Subj.: HVAC conflict 1st floor- 38"SA duct & beam
RFI No: **66.1**
Reference (dwg, spec): M1.2, S2.2.1
Subcontractor RFI: Monterey 02

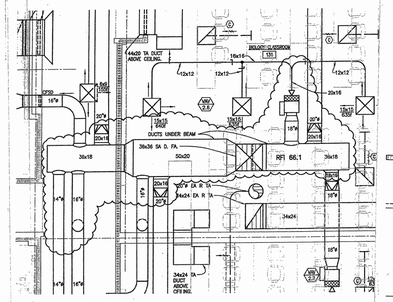
INFORMATION REQUESTED:
Original question in RFI No. 66:
In the process of detailing HVAC for underside of the second floor, we have identified the following conflict between HVAC duct and structural steel. On sheet M1.2, at approximately the line 4.8, the 38" branch near the 38" SA duct take off conflicts with the western LVL beam which frames to the column line following as shown on sheet S2.2.1. Note that ceilings are typically at 10'-0" height. Please advise.
Upon review of the response to RFI No. 66, it does not appear that the response is correct. Per Monterey: "How do you lay a 52"x22" wide duct into either a 30" round or 48" rear duct without using a transition that would need to be 48"x20" excluding insulation or liner that will be an add of approximately 4" to the 22" dimension. Please review the duct with the downlight, overhead light and projector screen interference? Please provide a drawing of this design change."

Division	1/27/2006 2:35:49 PM
See attached sketches for recommended duct routing / changes. For light and projector screen interference, recommend spanning ductwork similar to detail 10, sheet S.02 Note that actual amount of ductwork has not increased (actual size has decreased).

Subj.: HVAC conflict 1st floor- 20" EA duct conflicts with 34x24 duct at 4.9 line
RFI No: **72**
Reference (dwg, spec): M1.2, S2.2.1
Subcontractor RFI: Monterey 02

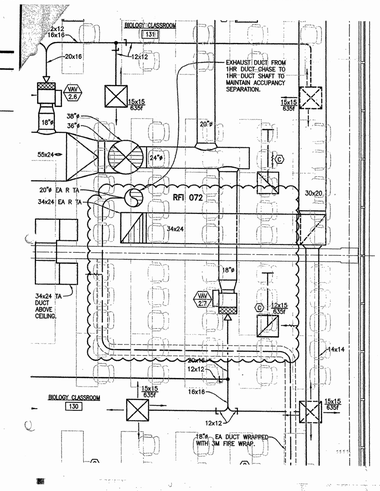
INFORMATION REQUESTED:
In the process of detailing HVAC for underside of the second floor, we have identified the following conflict between HVAC duct and structural steel. On sheet M1.2, at approximately 4.9 line, the 20" EA duct at G-4 line is in conflict with the 34x24 duct at 4.9 line. Please advise.

Sequence number: 1
Author: Donahoe
Subject: Deletion
Date: 12/6/2006 4:43:05 PM
Recommend re-routing the 20" diameter exhaust air duct to avoid conflict.
See attached for re-routing. Contractor to show re-routing within shop drawings for review.

Subj.: HVAC conflict 1st floor- EUP-2.2 conflict with light and ceiling tray
RFI No: **74.1**
Reference (dwg, spec): M1.2, S2.2.1
Subcontractor EFI: Mowbray 02

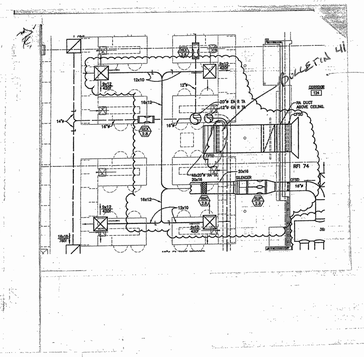
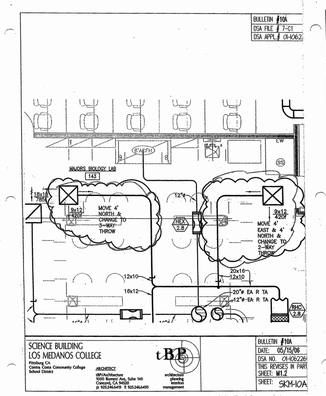
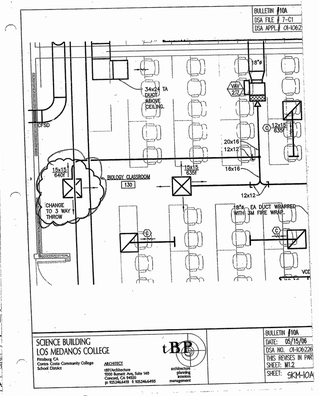
INFORMATION REQUESTED:
We have received the response to RFI Dis. 74 and forwarded this onto our subcontractor and mechanical engineer. Per our discussion on 1/23/06, they require a flat the response source to address this issue. Are they correct (adding 4) without a drawing of the response. Please provide a drawing of this design change. Please advise.

AIR CONDITIONING - 1ST FLOOR - PARTIAL PLAN

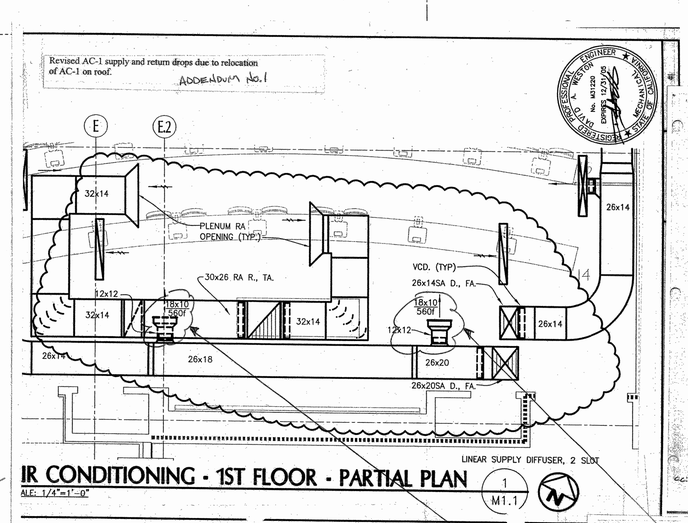
Revised AC-1 supply and return drops due to relocation of AC-1 on roof.
ADDENDUM No.1

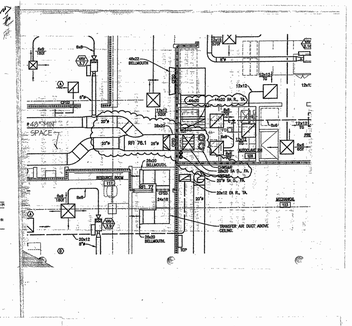
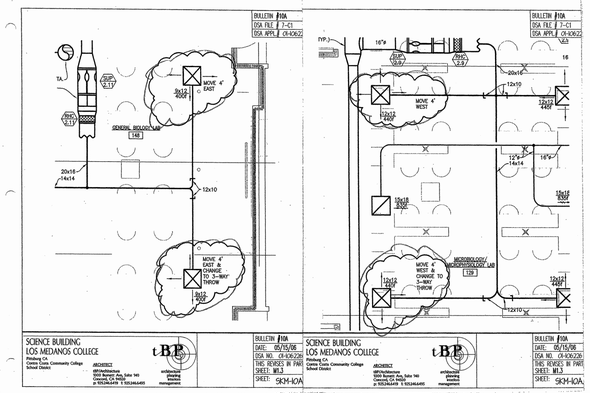
Per Details from REFERENCE:
Original question in RFI No. 76:
Per details on sheet LF1-02, at underside of the isolated floor, we have identified the following ducted exhaust inlets: duct size/ elevation cited. On sheet M1.3, the CHFD for the 24" EA duct at line 7.3 and the F.3 to the east balances the exterior and room 128 will be negatively pressured. The mechanical engineer has indicated that the 24" EA duct does into the ceiling. Also, there is not enough mechanical room for the CHFD inferior and the dual inlet. Please advise.

We have forwarded the response to RFI No. 76 to our mechanical subcontractor and drafter and have are requesting a drawing of the design change to clarify the RFI response. Please provide a response ASAP.

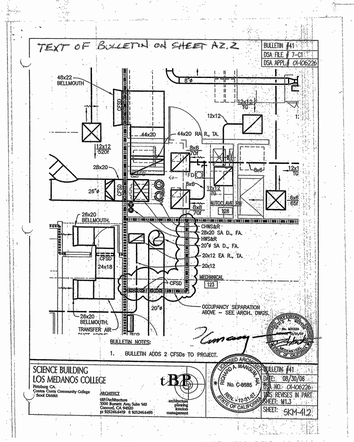
Per details on sheet LF1-02, there is a vent connected to building exhaust systems at corrosives storage base cabinets and acid/base storage base cabinets. Per review of the LF drawings, these types of cabinets occur in the following locations:
1. An island in room 125.
2. The west wall of room 145
3. The north wall of room 148
4. The west wall of room 235.

On sheet M1.2, a connection to the HVAC system is shown for item 2 above. No similar connection is shown on the contract drawings for the remaining 3 locations. Please advise.

Response as follows:
1) Room 125 - See attached sketch for mechanical connections.
2) Room 145 - No changes required - reference sheet M1.2 for connection(s).
3) Room 148 - Refer to General Note #18/Sheet LF1-00.
4) Room 235 - Refer to sheet LF1-02 - CS cabinet below fume hoods to have 3" diameter vent through bench-top behind baffle (extend 4" above bench-top).

Per previous discussions with RFP, venting this to general exhaust is acceptable, therefore, part 1 of the RFI is confirmed as correct.

As for the material -see response per RFP.

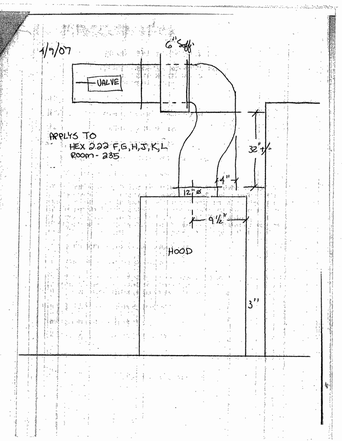
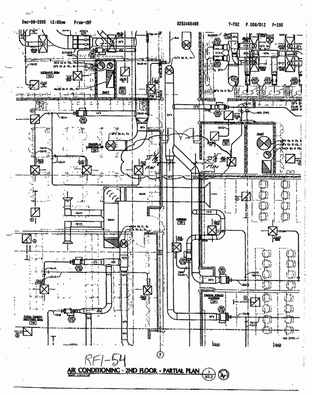
In review of the hood submittal, there appear no specific requirements of duct run off the top of the hood. Exhaust performance will not be affected. Should excessive noise be encountered it will be addressed with external measures at that time.

Upon further review and discussions, we take no exception to the proposed exhaust duct configuration per attached sketch dated 4/9/07 . This configuration will route the duct outside of the drop soffit conflict.

Please provide cost proposal (per attached sketch modifications) for review at earliest convenience.

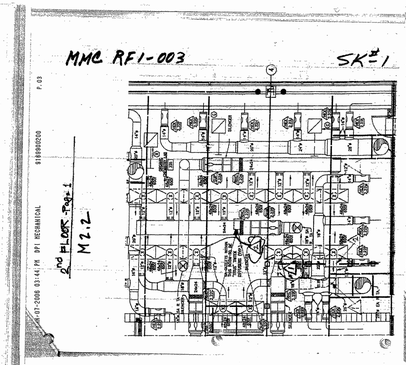
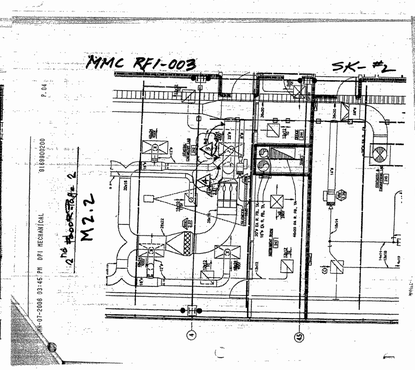
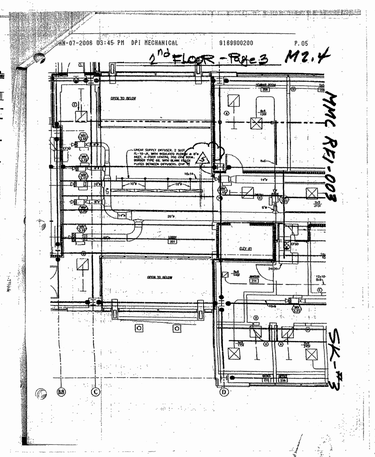
INFORMATION REQUESTED: Date: 1/30/06
Please note the attached RFI No. 3 from Monterey Mechanical regarding several conflicts on pages M2.2 and M2.4. Sketches are clouded and numbered per the RFI. Please advise and provide a sketch if necessary.

While in the process of detailing the ductwork layout with structural, architectural reflected ceiling plan, electrical & plumbing, we have discovered several conflicts on contract drawings: M2.2,M2.4

AIR CONDITIONING - 2ND FLOOR - PARTIAL PLAN

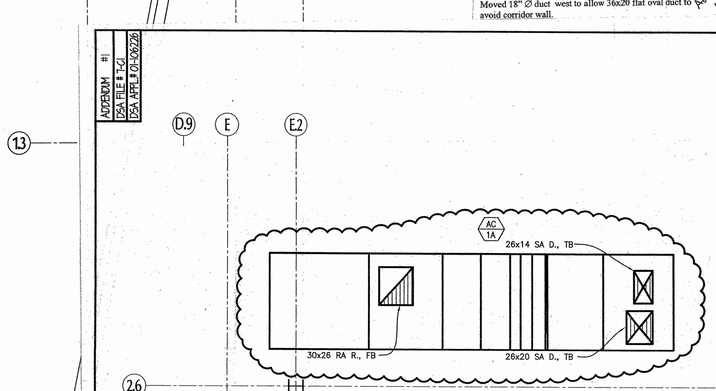
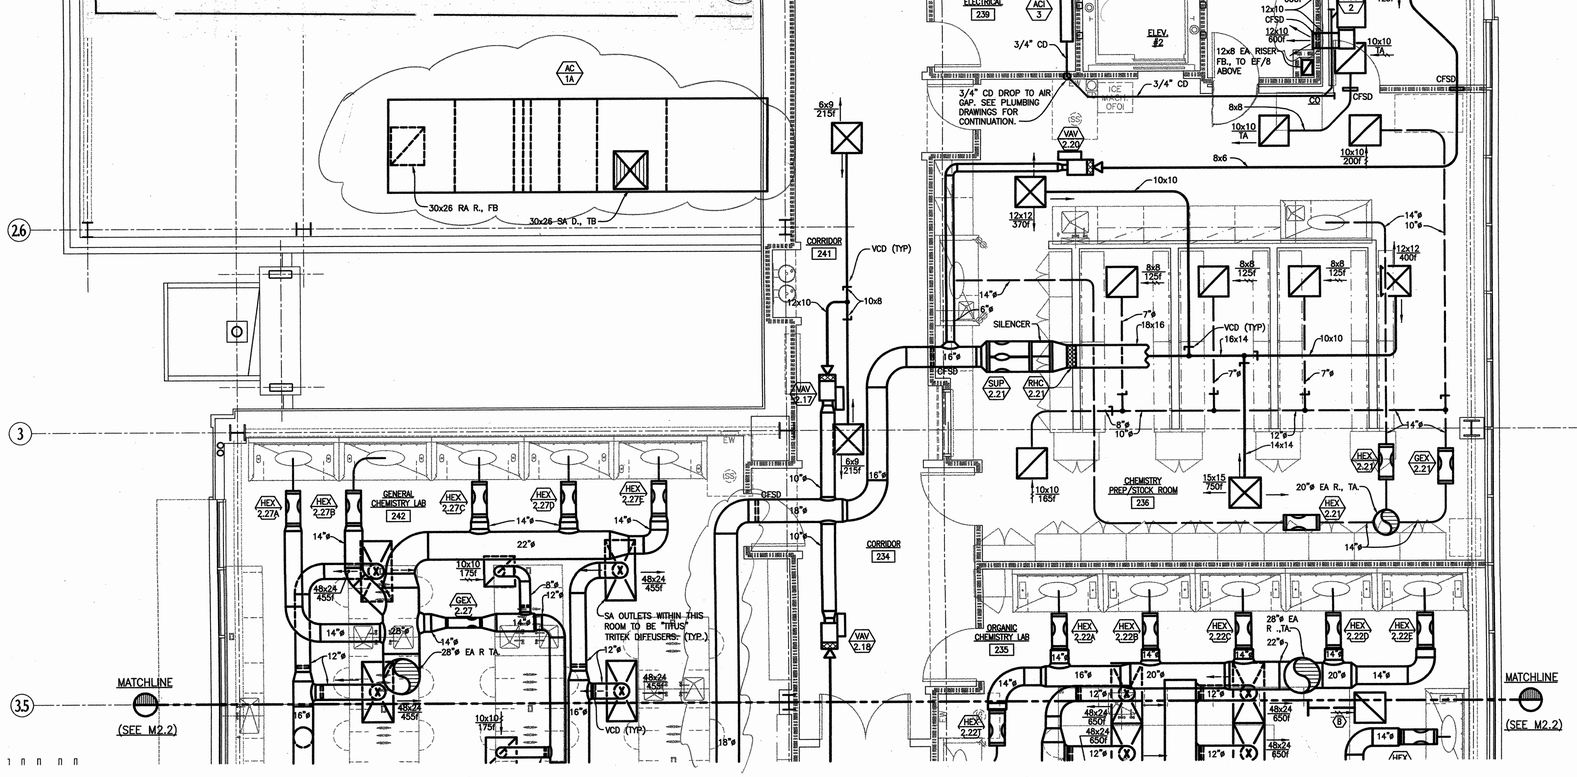
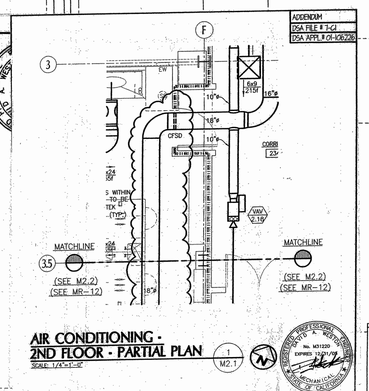
Moved AC-1 to provide clearances from walls at column lines 'F' and '26'.

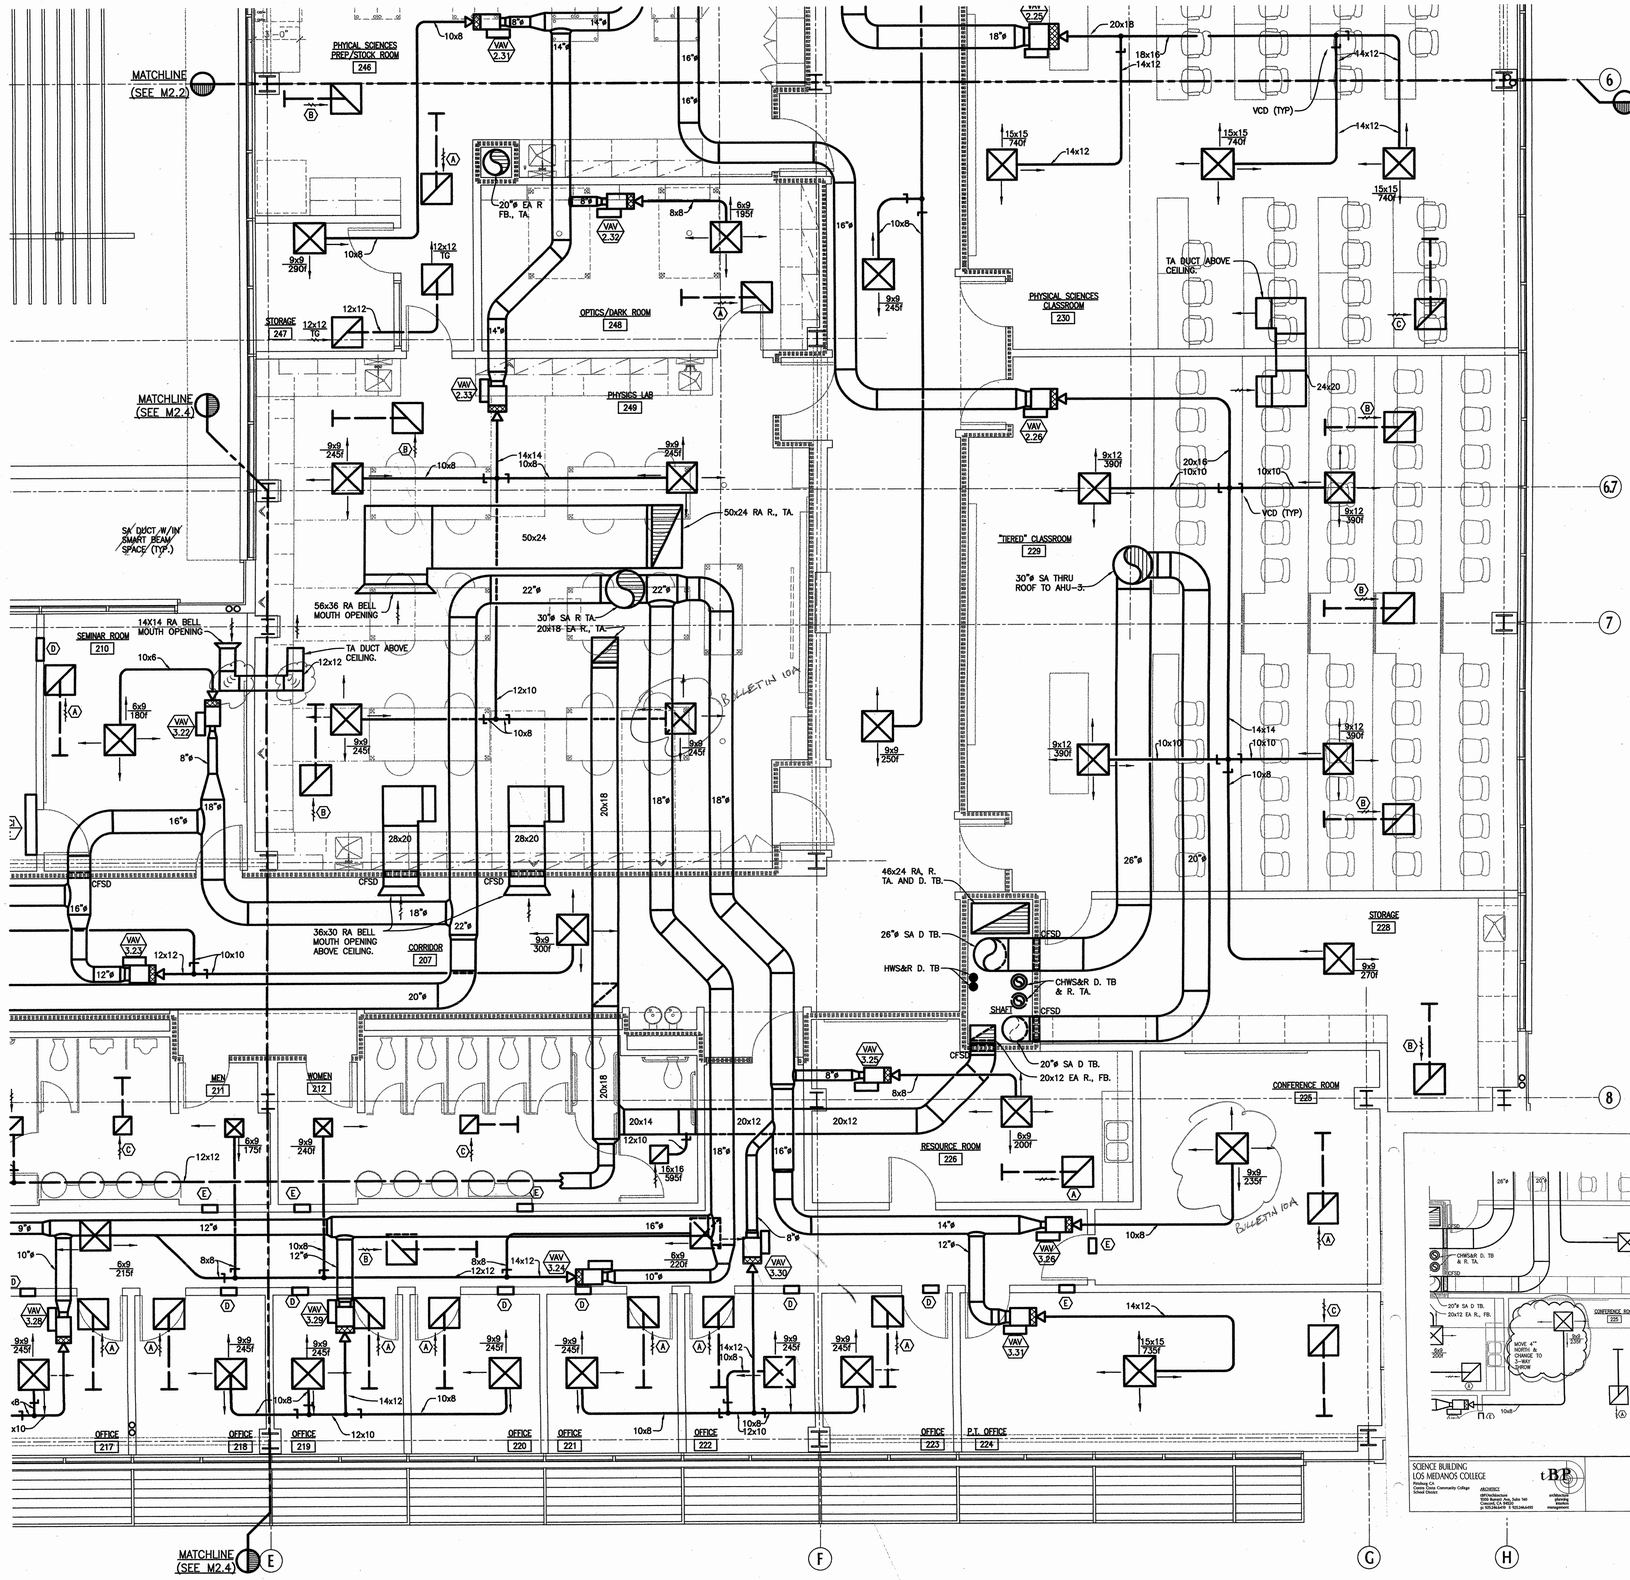
To: tBP/Architecture, 1000 Burnett Ave, Suite 140, Concord, CA 94520
Attn: Celia Chiang, Tom Beckett
Fax: 925-246-6496
Subj.: Hex valve duct size
Reference (dwg, spec.): M2.1, M2.2
Reply Requested By: 9/14/06

Structural approval will not be granted by DSA for this approach. Per discussion with M.E. at jobwalk 12/5/06, duct is to be transitioned up to allow bracing to be installed within lower 12" of soffit drop. No cost to owner.

BULLETIN #01
DATE: 1/04/06
DSA NO. 01-106226
THIS REVISES IN PART
SHEET: M3.1
SHEET: SK01-01

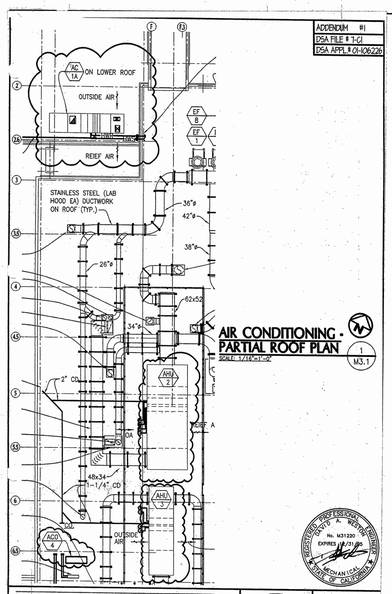
INFORMATION REQUESTED: Date: 9/28/06
HOT HOT HOT
Per roof plan on sheet M3.1 (as well as Addendum no. 1 which added AC) #) the orientation of ACO's 1, 2, 3 and 4 are shown. We would like to rotate each of these units 90 degrees from that shown on the plans. Rotating the units in the manner will present to shortest possible dimension of the unit supports to the flow of water running along the roof. This allows for a more prudent roofing scenario. Please advise if this is acceptable.

AIR CONDITIONING - ROOF PLAN

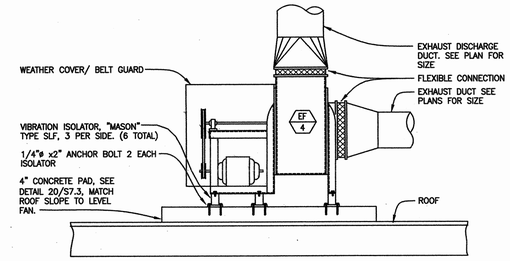
Revised AC/1A, AHU-2 and AHU-3 sizes at "Air Conditioning – Roof Plan" 1/M3.1. Moved AC/1A to provided clearances from parapet and building walls at "Air Conditioning – Roof Plan" 1/M3.1. Added ACO/4 next to ACO/1 at "Air Conditioning – Roof Plan" 1/M3.1.

HYDRONICS - FIRST FLOOR PARTIAL PLAN

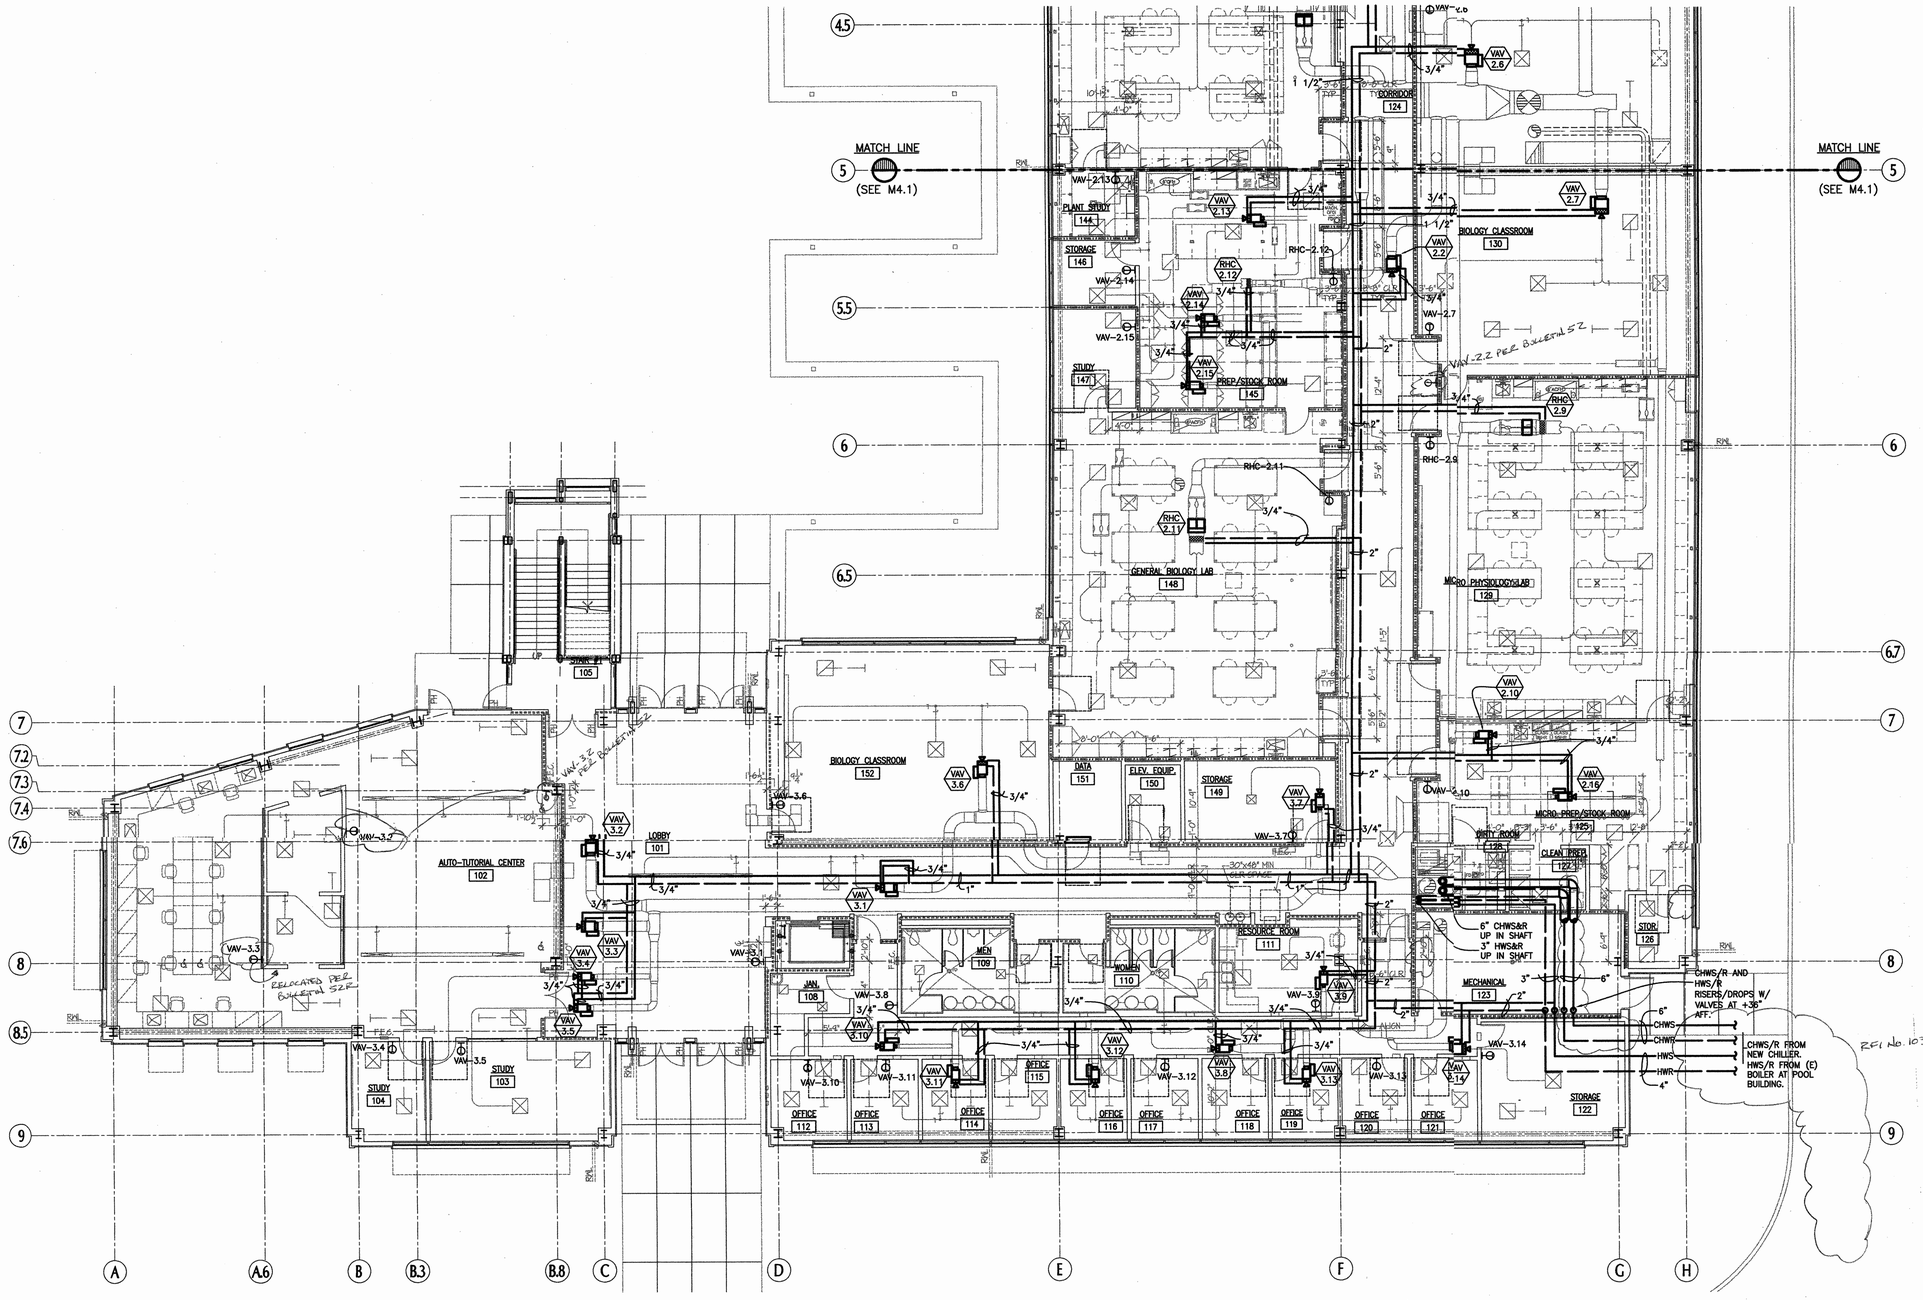
Moved CHWS&R and HWS&R closer to exterior door of Mechanical 123 at "Hydronics – First Floor Partial Plan" 1/M4.2. Added temperature sensor for VAV-2.16 in Storage 126 at "Hydronics – First Floor Partial Plan" 1/M4.2. Added TCP location in Mechanical Room 123.
